SERVICE BULLETIN

N° **139-694**

ATA 56 – WINDOW GASKET UPGRADE

This Service Bulletin is issued in order to provide the necessary instructions to introduce a new gasket installation on the basic jettisonable emergency exit of the helicopter .

Figure 32

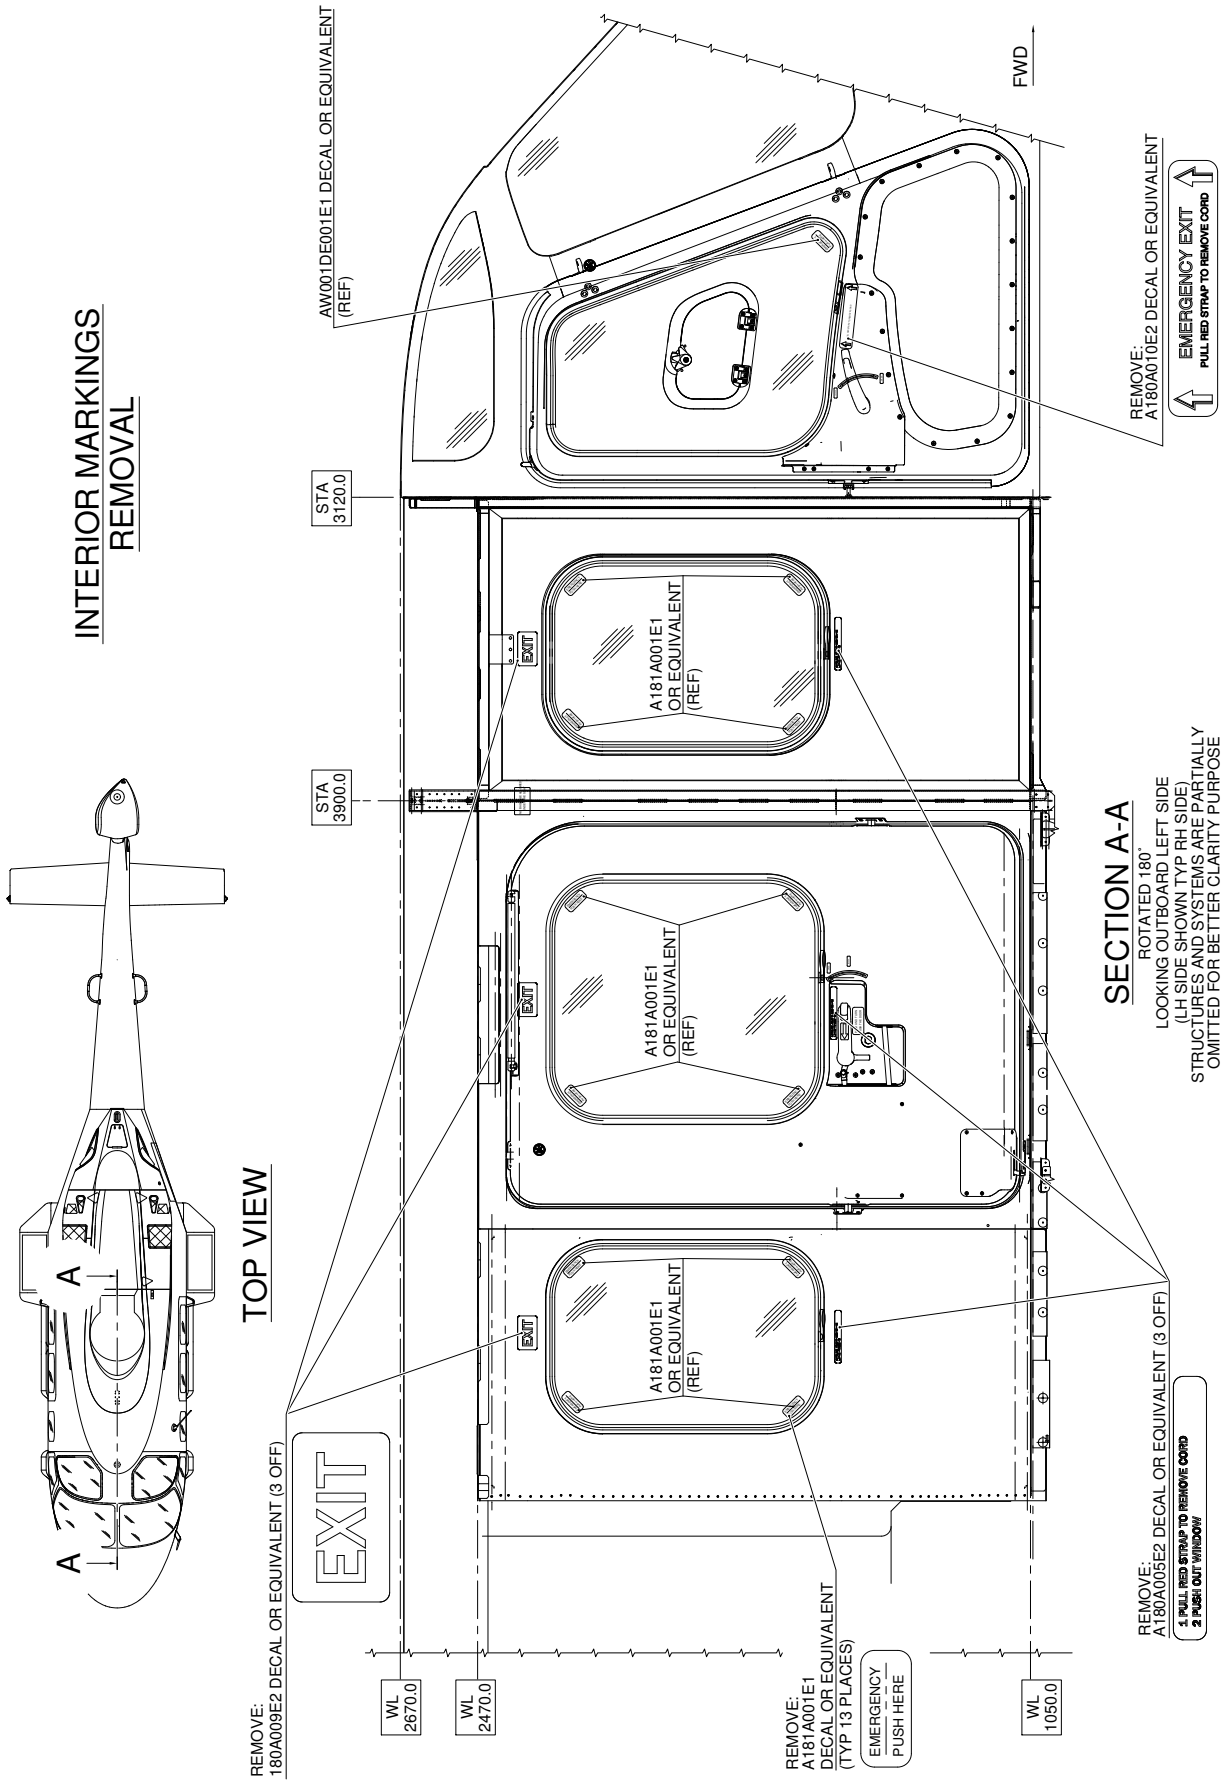
2. In accordance with the applicable steps of AMP DM 39-A-11-00-01-00A-520B-A and with reference to Figure 32, remove the following decals from the left inner side of the helicopter:

Figure 33

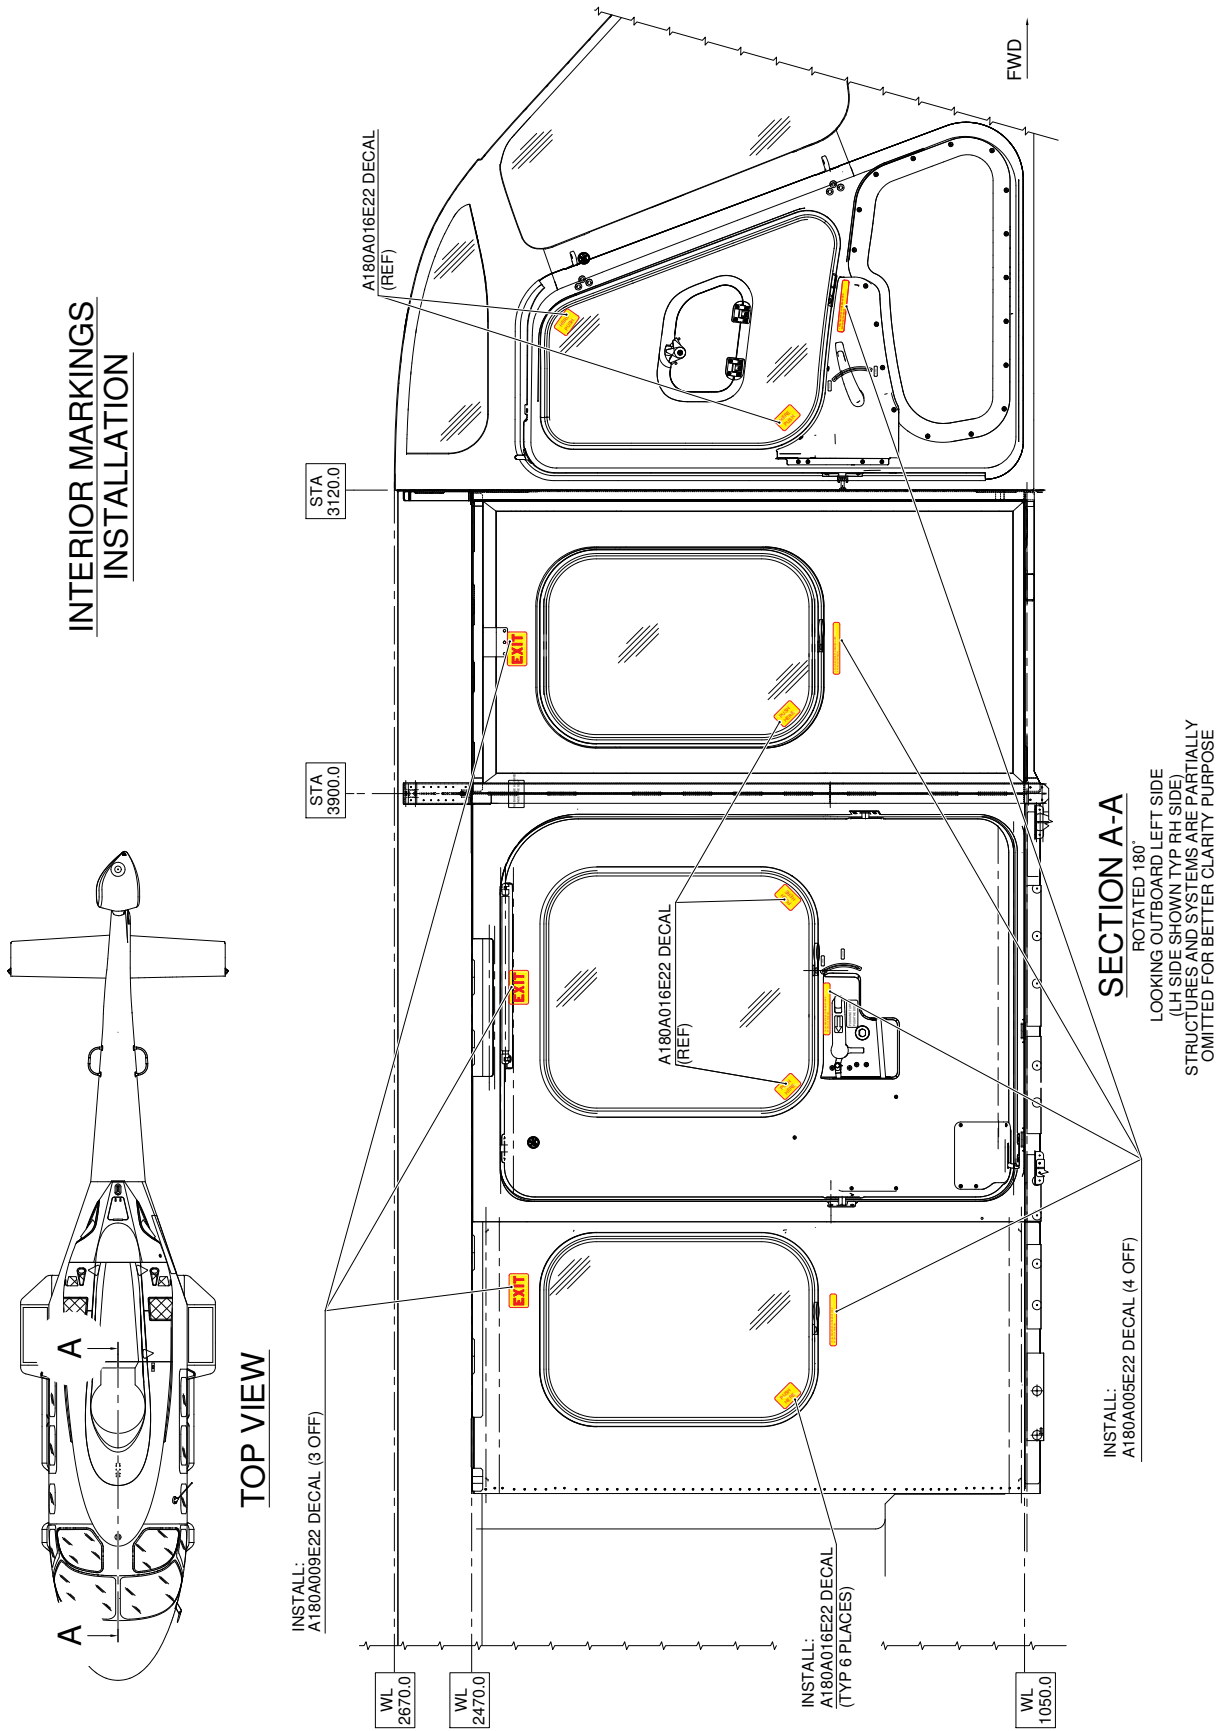
5. In accordance with the applicable steps of AMP DM 39-A-11-00-01-00A-720A-A and with reference to Figure 33, install the following decals on the left inner side of the helicopter:

- n°6 decals P/N A180A016E22;
 - n°3 decals P/N A180A009E22;
 - n°4 decals P/N A180A005E22;
6. In accordance with the applicable steps of AMP DM 39-A-11-00-01-00A-720A-A and with reference to Figure 34, install the following decals on the left outer side of the helicopter:

Figure 34

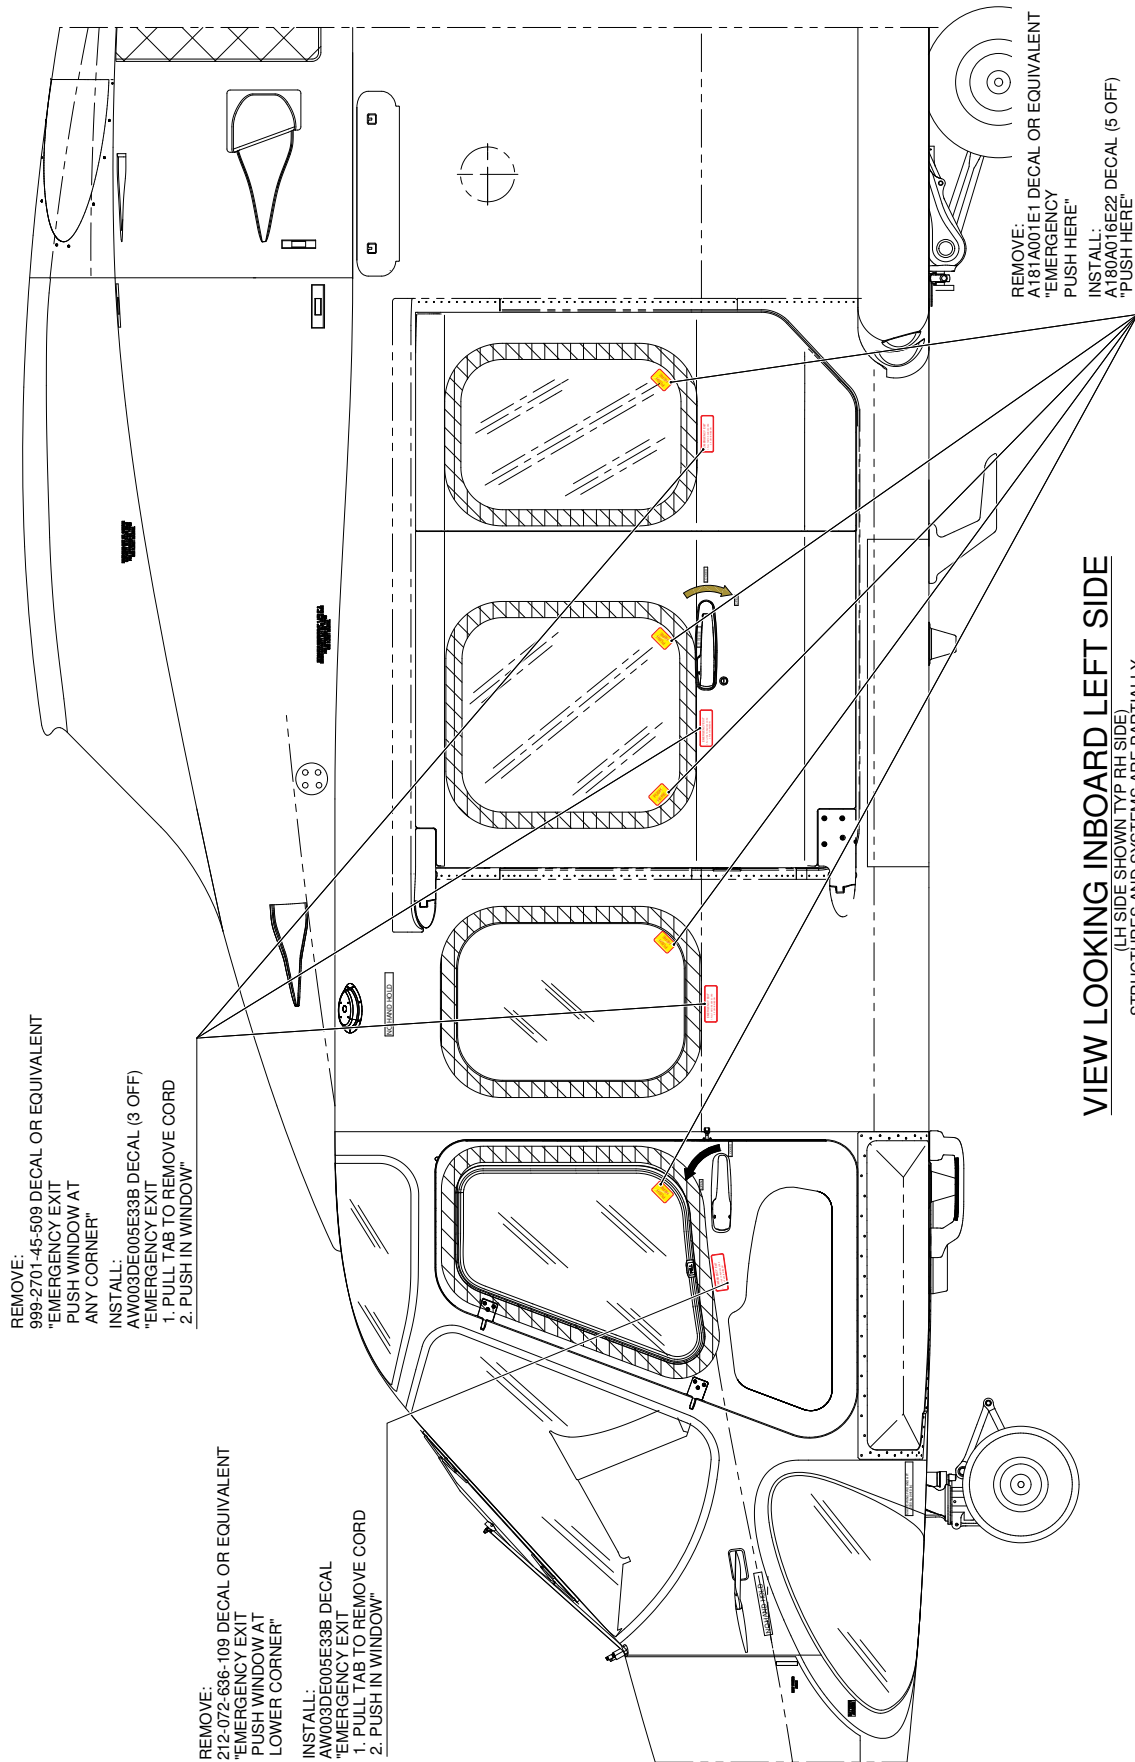
3. In accordance with the applicable steps of AMP DM 39-A-11-00-01-00A-520A-A and with reference to Figure 34, remove the following decals from the left outer side of the helicopter:
